STAFF RECOMMENDATION
208-210 Broadway
October 19, 2016

Application: New construction-addition, Alterations
District: Broadway Historic Preservation Zoning Overlay
Council District: 19
Map and Parcel Number: 09306211100
Applicant: Kristy Angyal/ Kip A. Moore & Associates
Project Lead: Robin Zeigler, robin.zeigler@nashville.gov

<p>Description of Project: The project is for rehabilitation of two contributing buildings and a rooftop addition on one of the buildings.</p>	<p>Attachments A: Photographs B: Site Plan C: Elevations</p>
<p>Recommendation Summary: Staff recommends disapproval finding that the project does not meet section II.of the design guidelines for alterations to historic buildings.</p>

PROPOSED
GROUND FLOOR PLAN

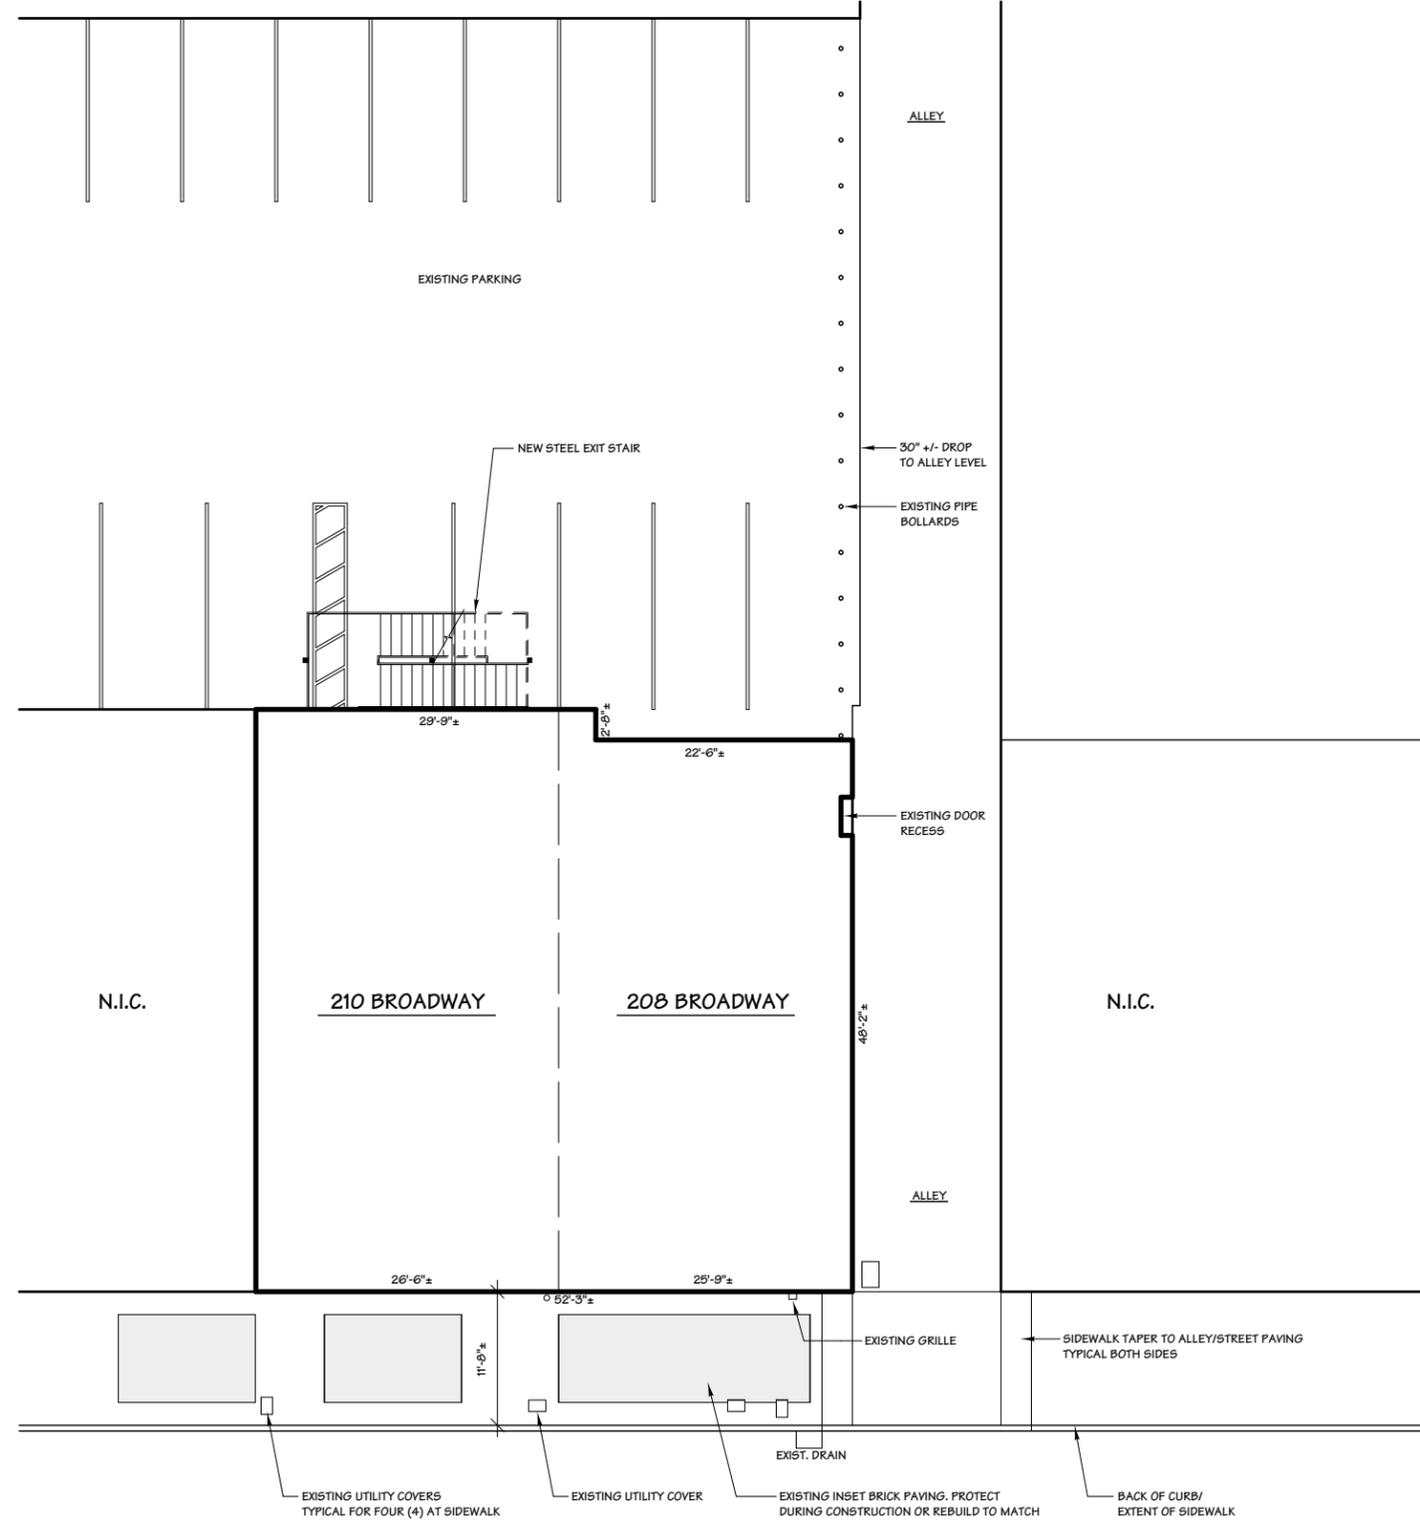
Interior changes: Although the interior of buildings themselves is not reviewed, the design guidelines do state that interior changes that affect the exterior should not be undertaken. The current plan is to remove the entirety of the party wall between the two buildings. Staff is concerned that it could not only affect the exterior look of the buildings but cause the complete failure of the two buildings. In addition, the floor lines of 210 Broadway will be altered which means that the second level will cover a portion of the transoms. Staff finds that without a scope of work explaining how the building will be stabilized during construction, an engineer report confirming that the buildings' structural integrity will not be compromised with this alteration, and without placing the floors in a location where they do not obscure openings, such changes are inappropriate and do not meet section II. General Principles for Facades and section V for demolition.
